AUXILIARY BUILDING UNDERPINNING REVIEW OF CRITICAL AREAS

NRC Auxiliary Building Audit
September 15, 1983

SUBJECT: NOTICE OF AUDIT MEETING ON AUXILIARY BUILDING
CALCULATIONS - MIDLAND PLANT, UNITS 1 & 2

PURPOSE: Audit calculations of the Midland Auxiliary Building based upon
soil modulus determined from underpinning pier load test.

[Eye bar]

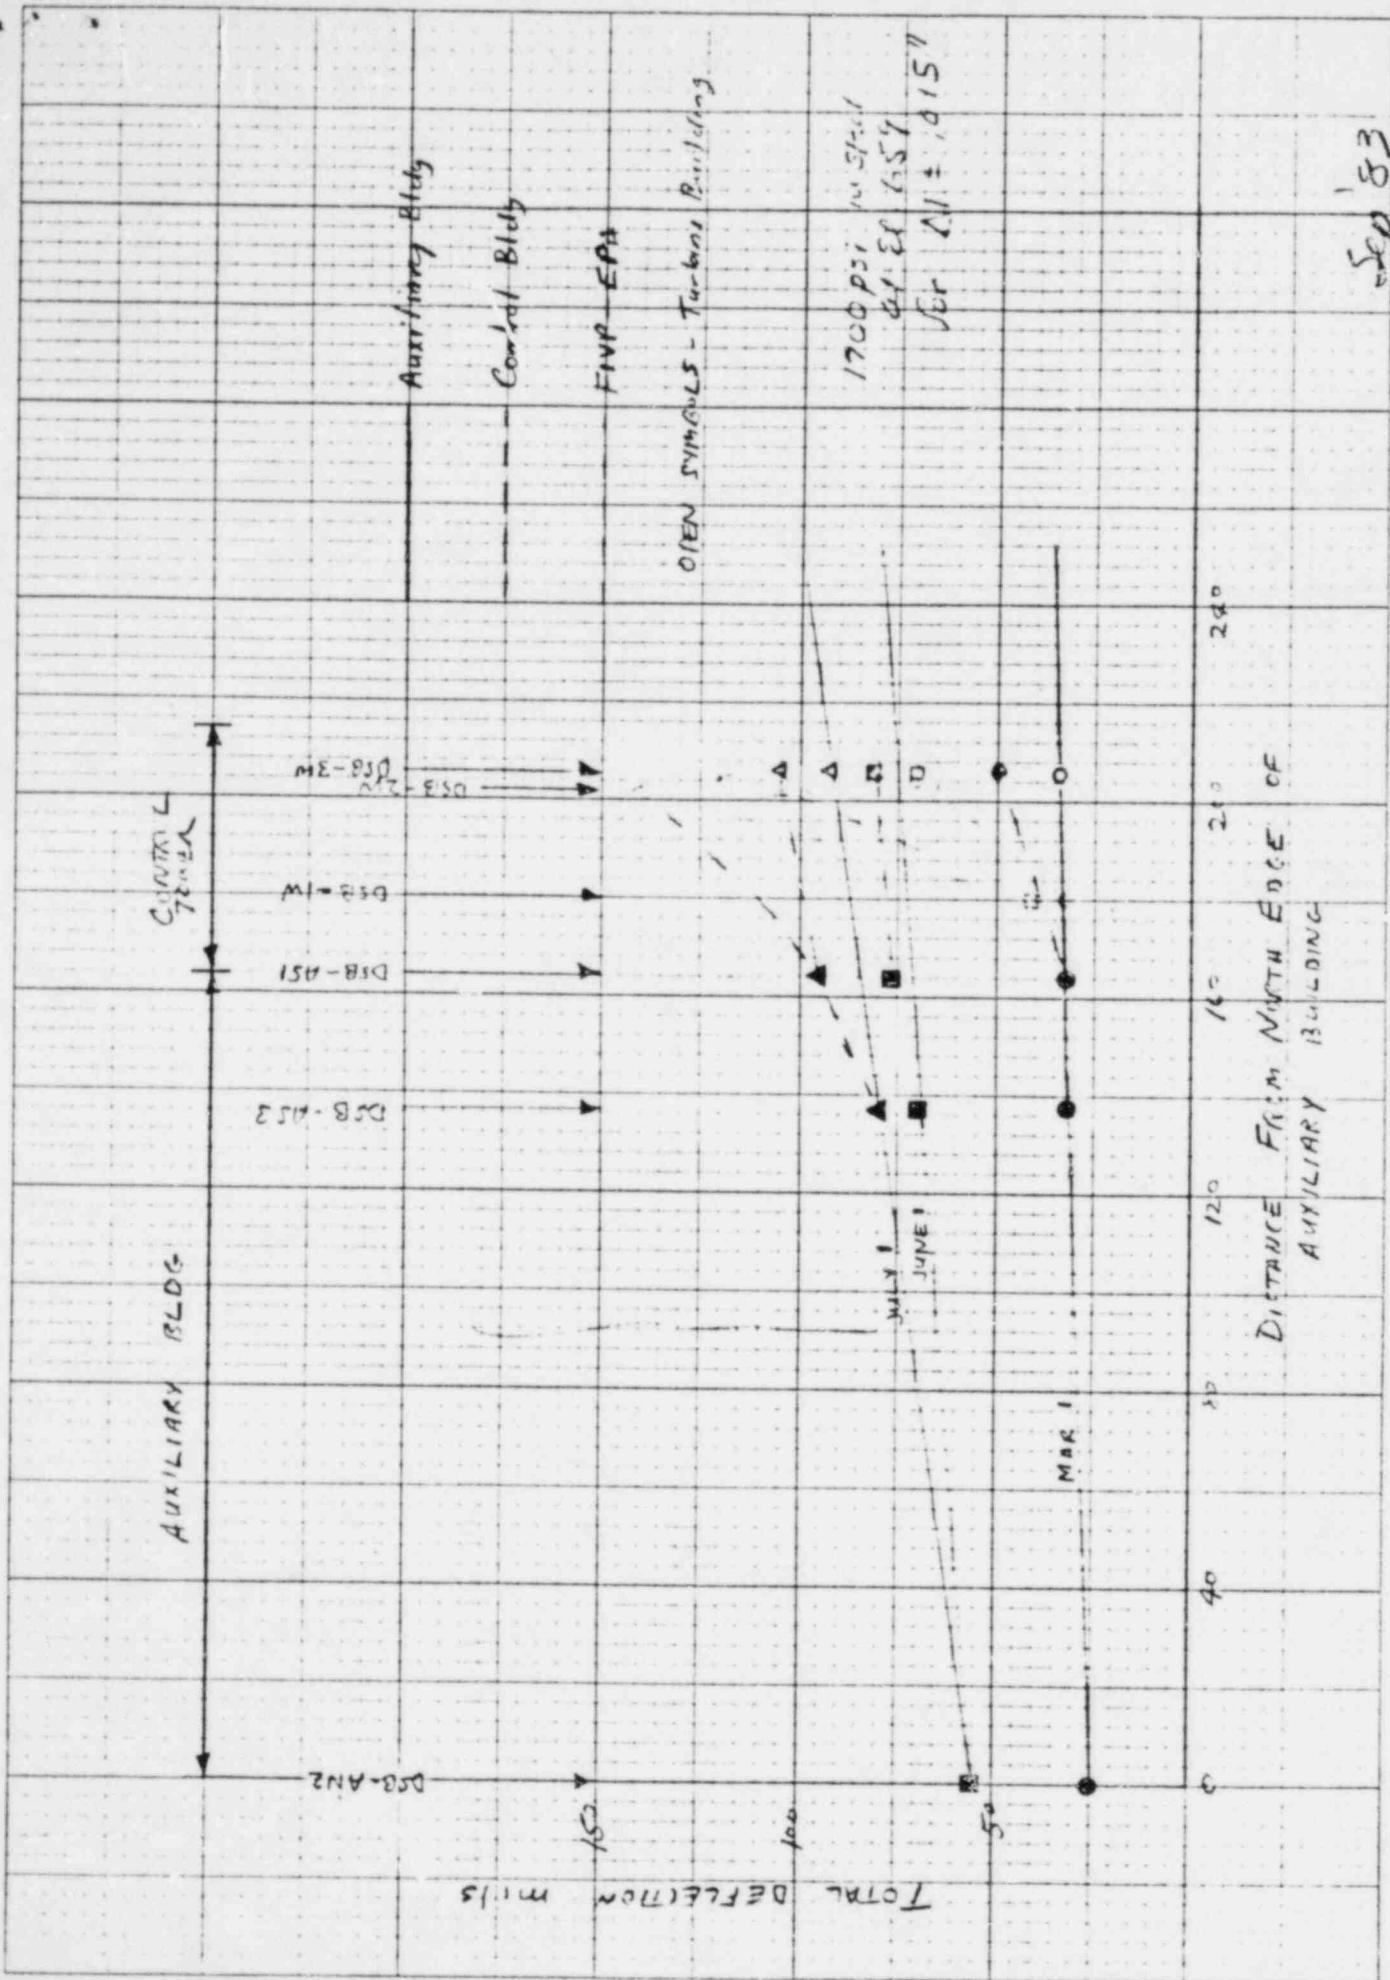
* new question - are stains (existing rebar vs long fix)
compatible

* new question - do we need monitoring of fix (i.e. strain
gages)
live to settlement over 40 yrs

[
order with 2 bars tightened (will get stuck
out of system) before grouting &
torquing of floor flange bolts
]

* check with mechanical to see if equipment can take elongation

TYPICAL SECTION

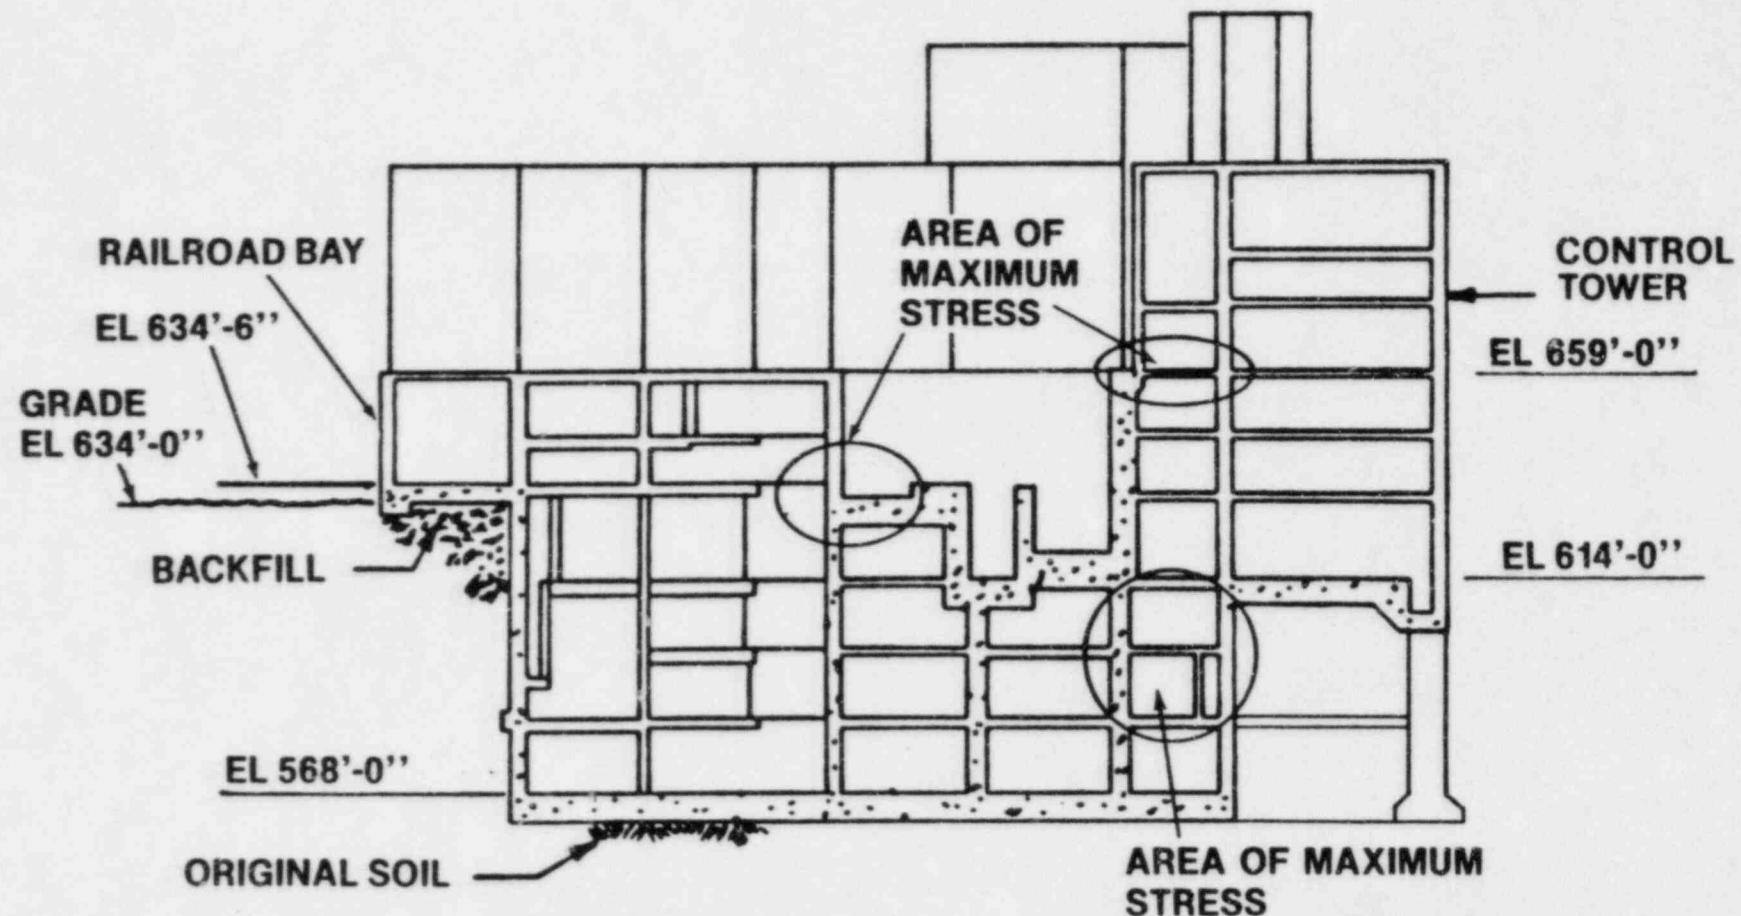
Explain critical trans stresses
other slab @ 659

narrow slab adjacent to
fuel pool

CALCULATED DISPLACEMENTS AT DEEP SEATED BENCHMARKS FOR $K=30$ (NOTE = NO ELEMENT CRACKED)

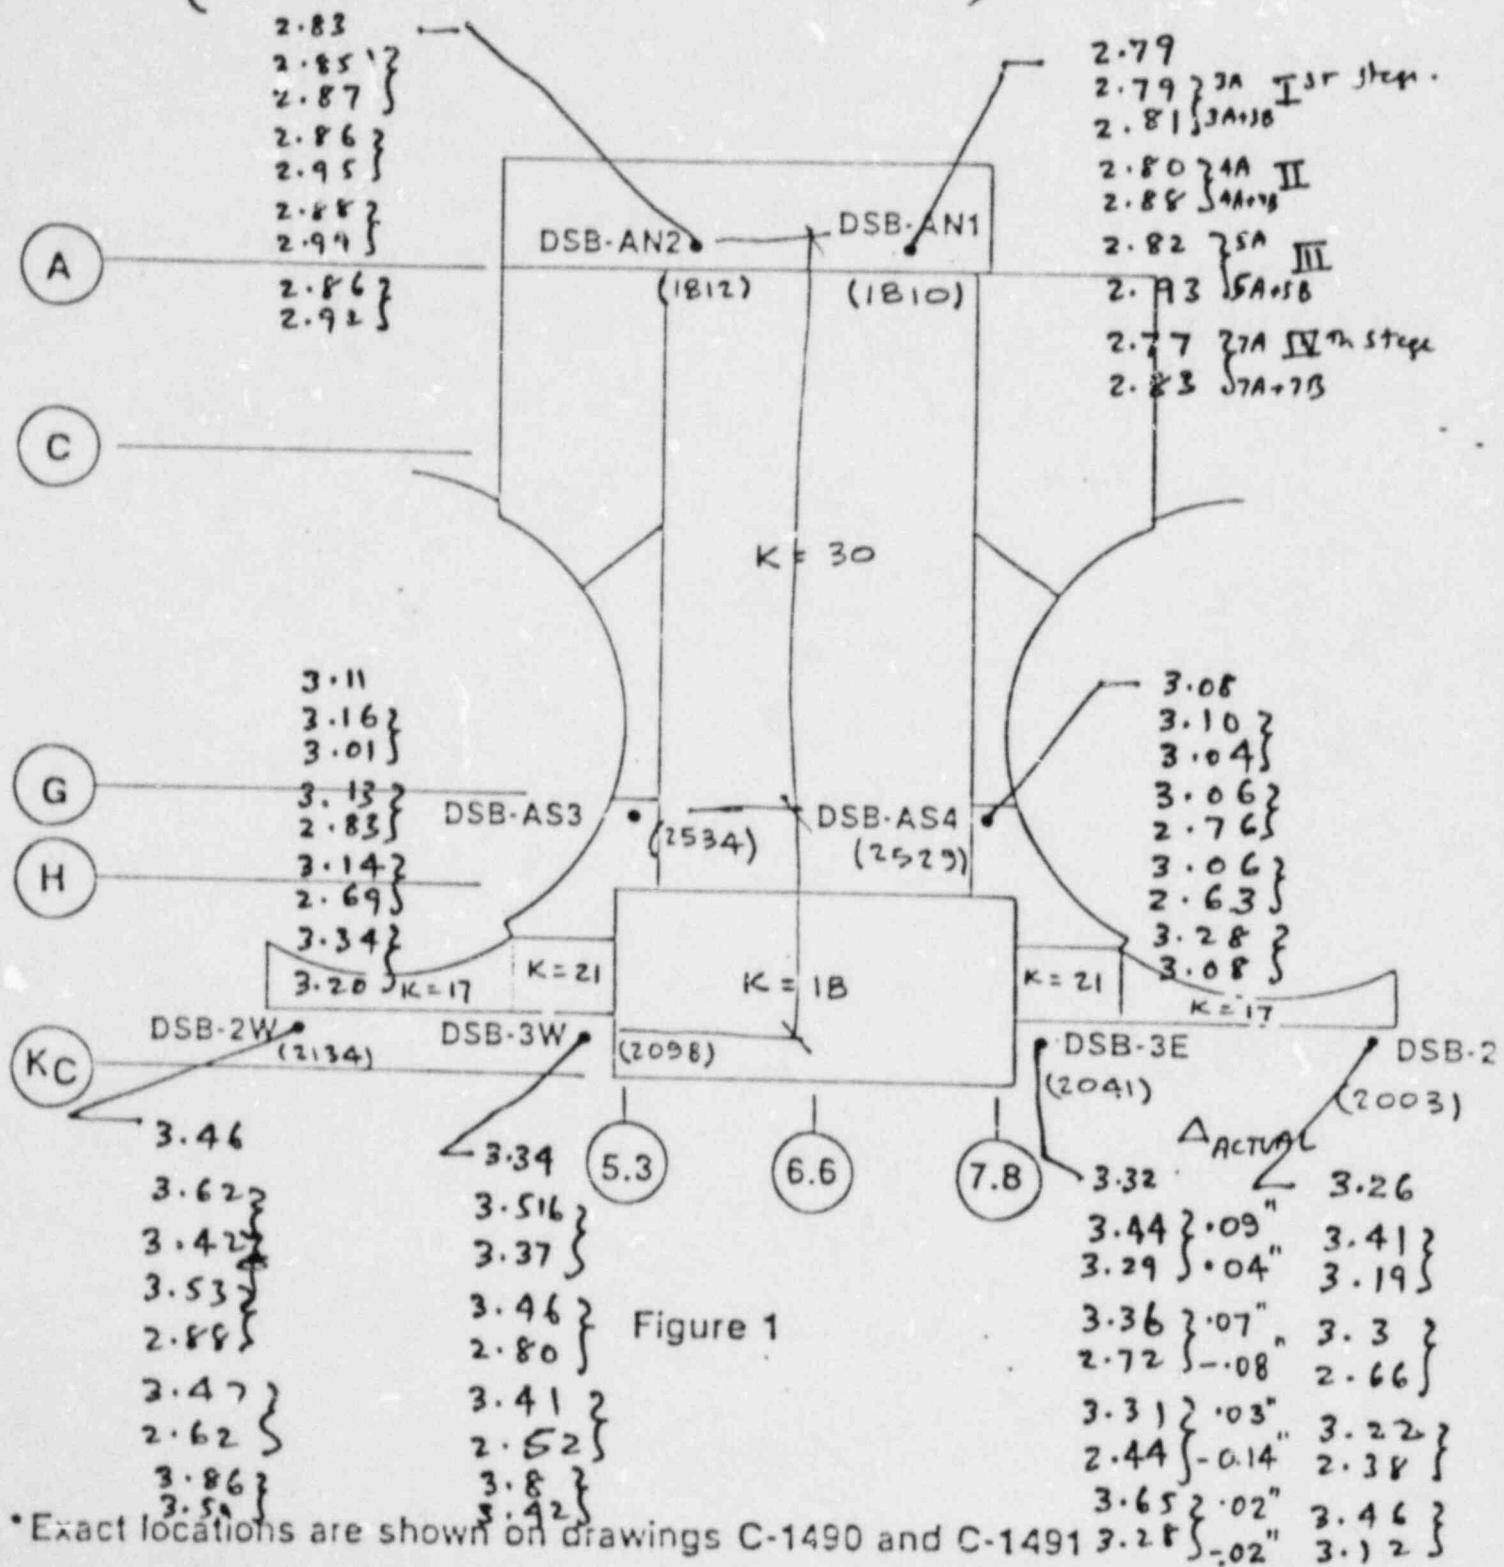
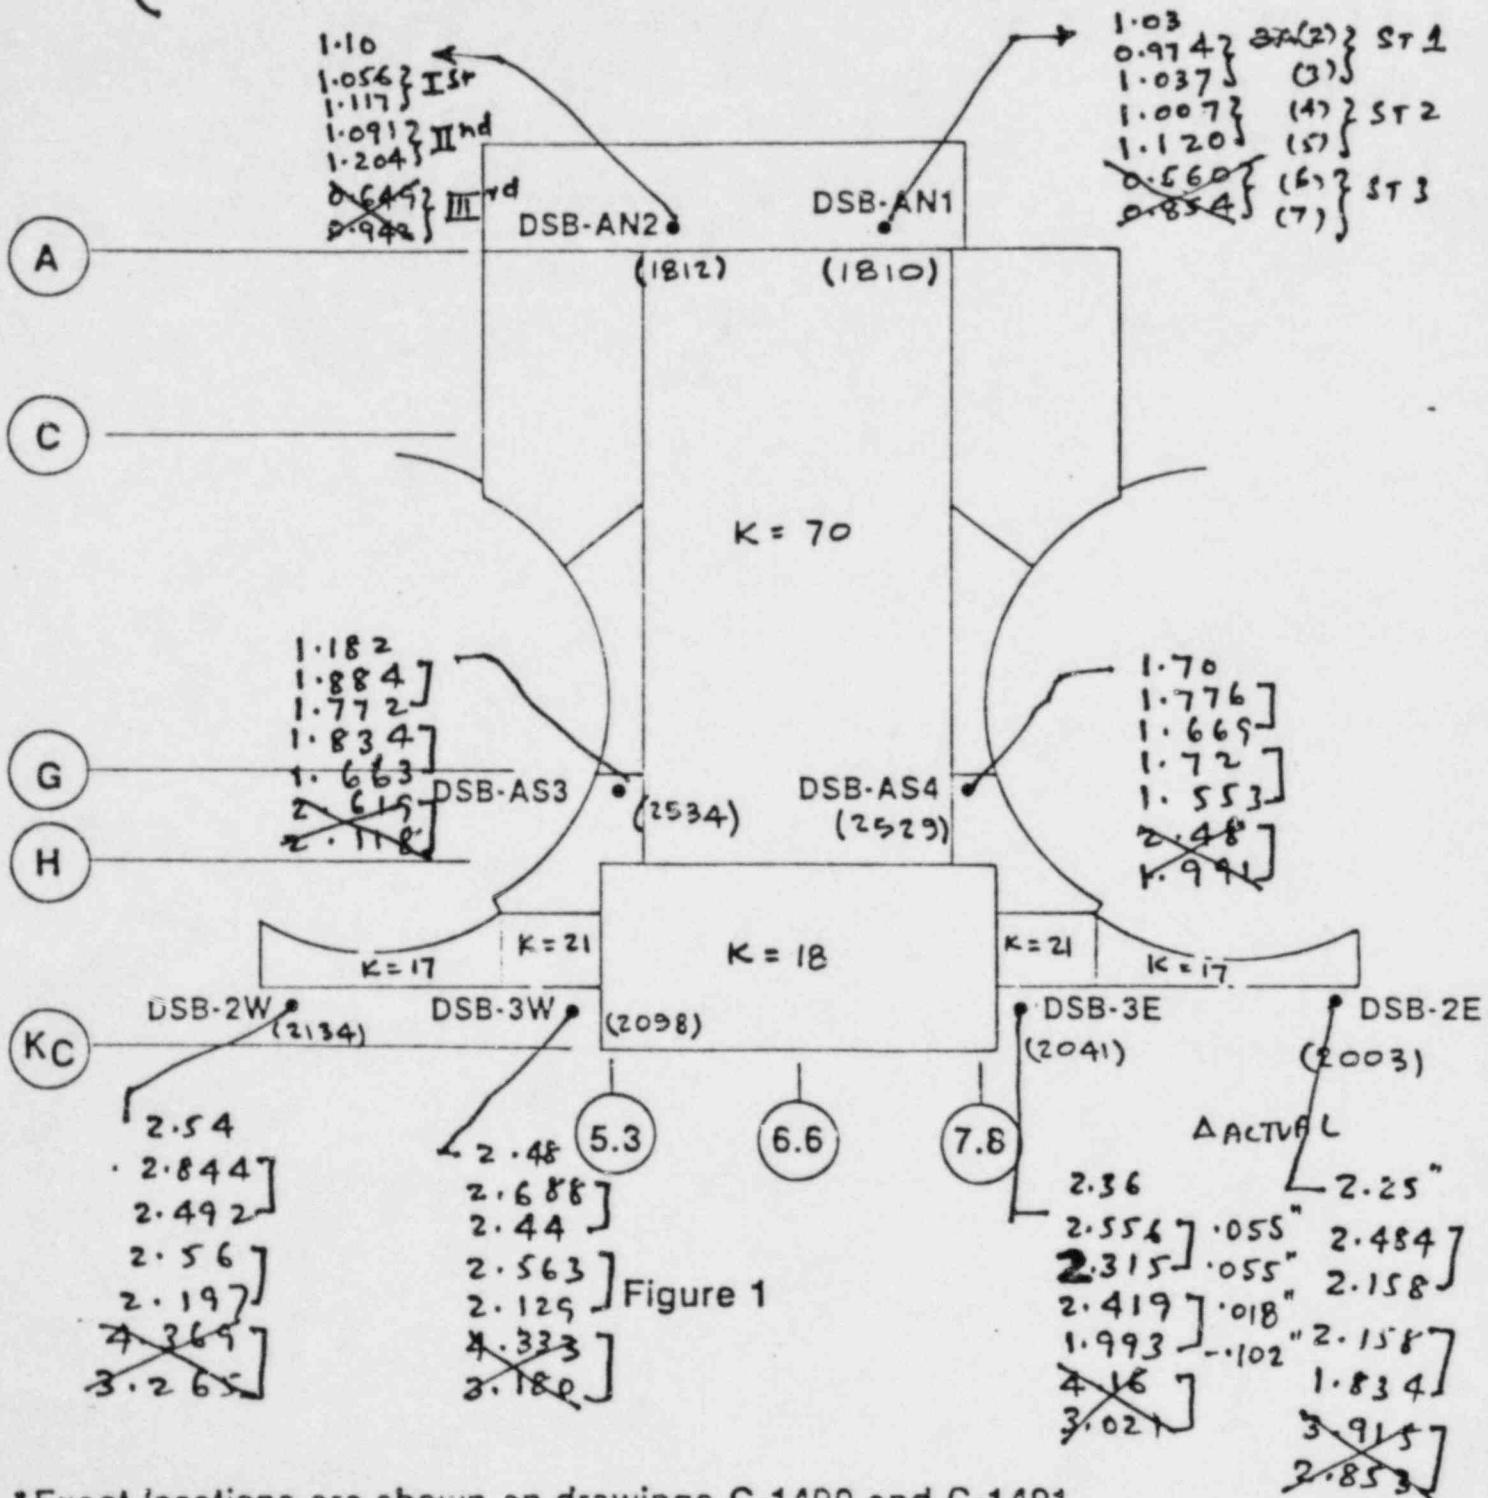
3rd question rigid body rotation

plot for $\frac{1}{4}$ "(old rung) plus Δ_2 for both

* gave us Δ_1 plot for new parameters
with .21" diff. & only .17" Δ_1 ?

What the hell is diff. on middle
of building or Edge to Edge
